**From:** Suraj Nagaraj [snagaraj@tesla.com]  
**Sent:** 6/11/2020 5:31:12 PM  
**To:** Wright, DavidA [Wright.DavidA@epa.gov]; Vineet Mehta [vineet@tesla.com]; Rohan Patel [rohpatel@tesla.com]; Ray Wang [raywang@tesla.com]  
**CC:** Cullen, Daniel [Cullen.Daniel@epa.gov]; Wehrly, Linc [wehrly.linc@epa.gov]; Rojeck, Tristin [rojeck.tristin@epa.gov]; Snyder, Jim [Snyder.Jim@epa.gov]; Bunker, Byron [bunker.byron@epa.gov]  
**Subject:** RE: Slides for Vehicle Efficiency Calculations

Having reviewed the calculations and data provided by Tesla for estimating the vehicle road load force when the vehicle is operating at standard ride height, EPA accepts the calculation methodology and the road load force blending methodology described by Tesla.

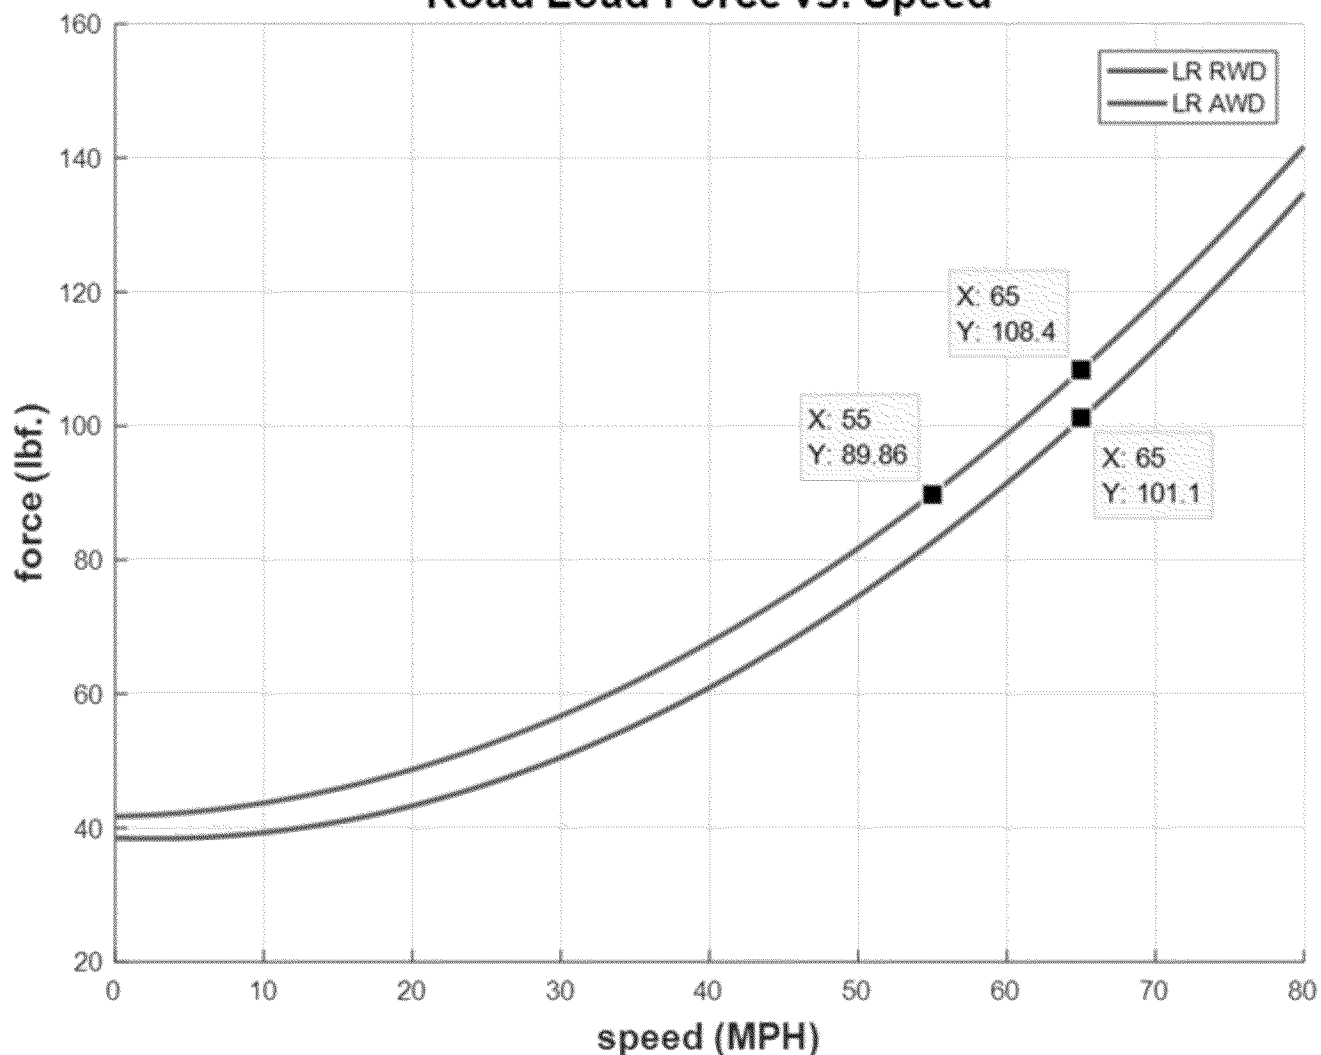
After reviewing Tesla's confirmatory test and decision information and the application for test group JTSLV00.0L23, a few questions arose based on the comparison of this LR AWD version of the Model 3 compared to the initial LR RWD option. Attached is a spreadsheet that uses calculations from SAE J1634 for MCT data analysis to compare the results of the two Model 3 variations per the values given in the certification applications. It came to our attention that the MCT range for the LR RWD option was 371.47 miles and the MCT range for the LR AWD option was 420.4 miles, while the charge depleting tests showed a decreased range and decreased MPGe values for both the HWY and UDDS cycles for the LR AWD option.

It is understood that some optimization will occur based on the dual motor operation at higher speeds, but there is a drastic difference between the RWD and AWD variations that may not be clearly represented on the charge depleting HWY test. Values highlighted in yellow on the appended spreadsheet are of particular interest. An explanation for the differences would be appreciated and would aid the review process.

The AWD MCT range is larger simply due to a different cruising speed having been used for the CSC sections, which make up the majority of the distance travelled during the MCT test.

We used 65 MPH for CSC during the RWD test, due to testing time constraints, and EPA ran the confirmatory test using 65 MPH. In preparation for the AWD testing, we reviewed the test sequence and found that 55 MPH is allowed per current SAE standard (J1634 2012) version, per CFR Section (600.116-12 and 600.001 “Incorporation by reference”).

The road load curves we have submitted show that there could be no physical explanation for the AWD car being more efficient than RWD at a given cruising speed. This is consistent with the results submitted for the HWY and UDDS cycles. Torque split optimization cannot close the gap in road load, because the PM machine is shared by both variants and is more efficient than the front IM in the AWD variant. See Road Load Force comparison below at different CSC speed.
